FORD:

2006-2015 F-650, F-750

ISSUE

Some 2006-2015 F-Super Duty 650/750 vehicles equipped with exterior tubular stainless steel west coast style mirrors may have a loose mounting bracket due to poor rivet retention.

Figure 3 - Article 15-0164

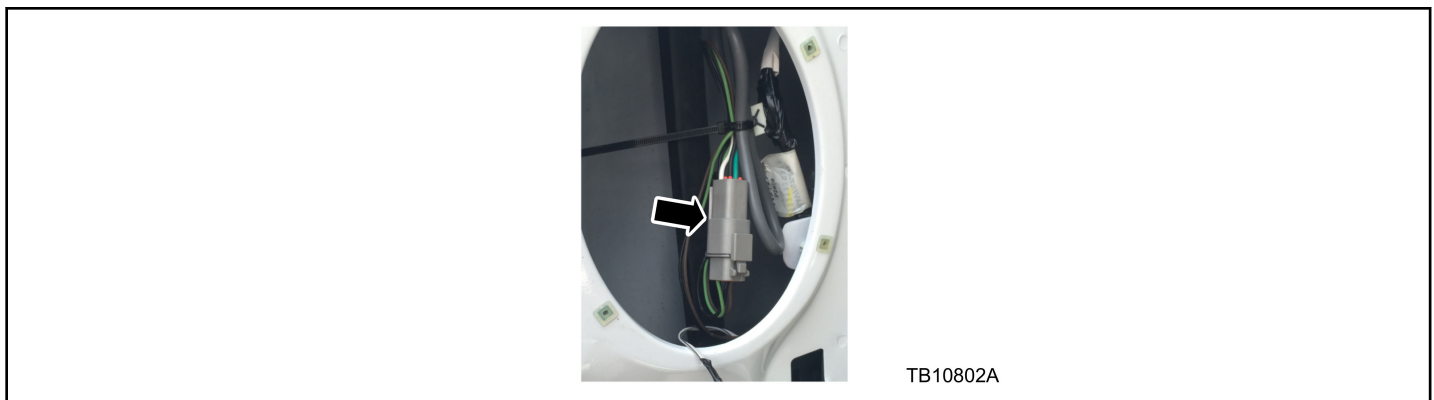
- 6. Locate the exterior tubular stainless steel west coast style mirror wiring from the door sail area and follow the harness down to the mirror 6-way electrical connector, accessing it via the speaker opening in the door sheet metal. (Figure 3)

- 7. Is the color of the exterior tubular stainless steel west coast style mirror electrical connector shell black? (Figure 3)
 - a. Yes - cut the yellow/white/green wires 100 mm (4") from the back of the 6-way mirror connector.
 - b. No - cut the green/white/black wires 100 mm (4") from the back of the 6-way mirror connector.
- 8. Remove the four (4) rubber plugs to access the sail panel retainers.
- 9. Remove and discard the four (4) exterior sail panel attachment nuts. (Figure 4)

Figure 4 - Article 15-0164

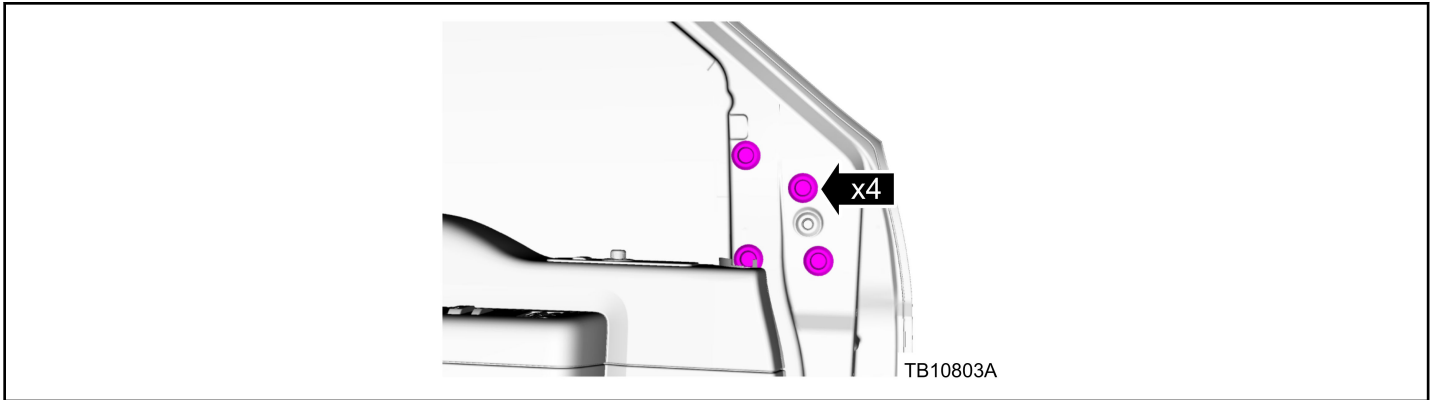
12. Feed the new sail mirror wire harness through the access hole in the sail mount surface as the mirror assembly is placed into its mounting position and install the four (4) mirror attachment nuts. Tighten to 11 Nm (97 lb-in) (Figure 4).
